## **PARTS BULLETIN No. 5-19**

### **Subject: Multistream Steerer Upgrade Parts**

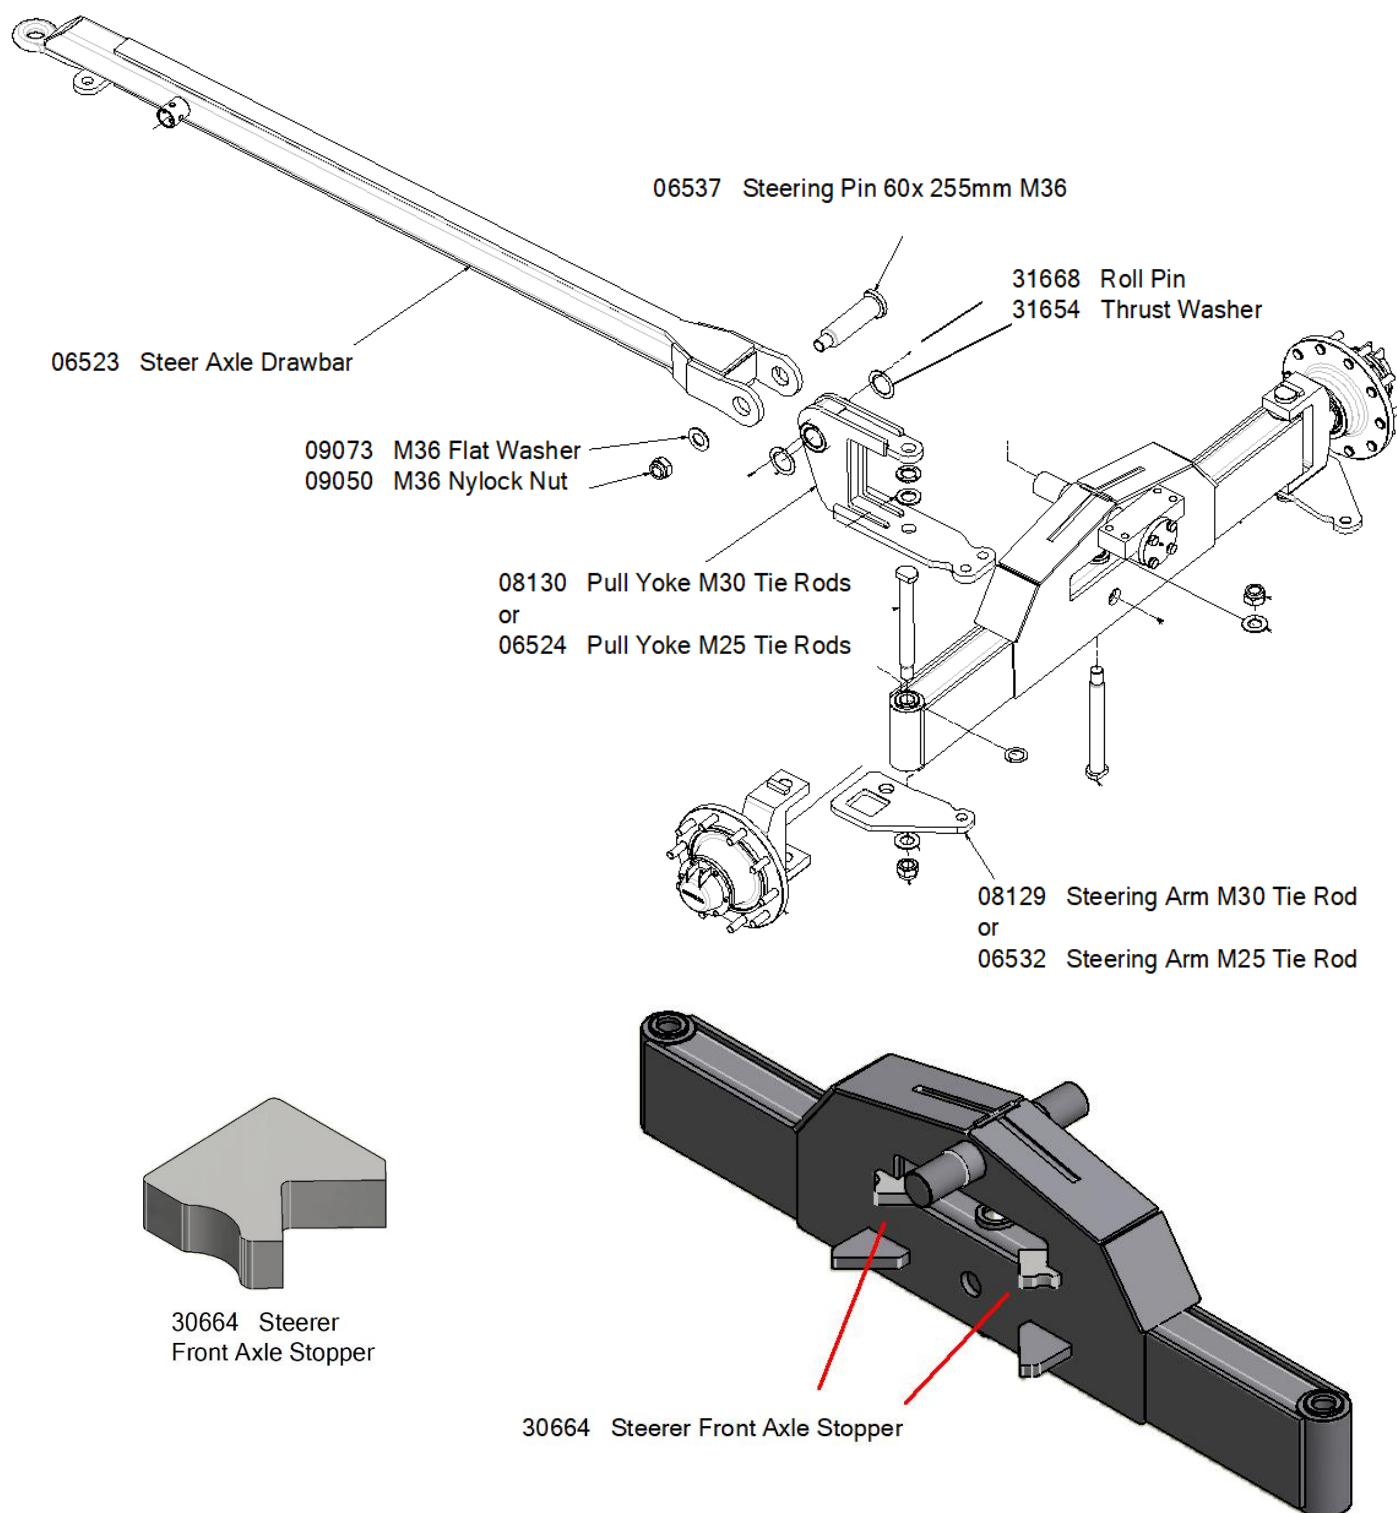
To improve strength and durability, the Multistream Steer Axle has been upgraded. These upgrades include changes to the materials in the Steer Axle Drawbar and Pull Yoke that now utilise a larger 60mm in diameter M36 Steering Pin (was 40mm dia).

**Please Note:** 30664 Steerer Front Axle Stoppers x 2 will require welding onto the axle in the positions shown below.
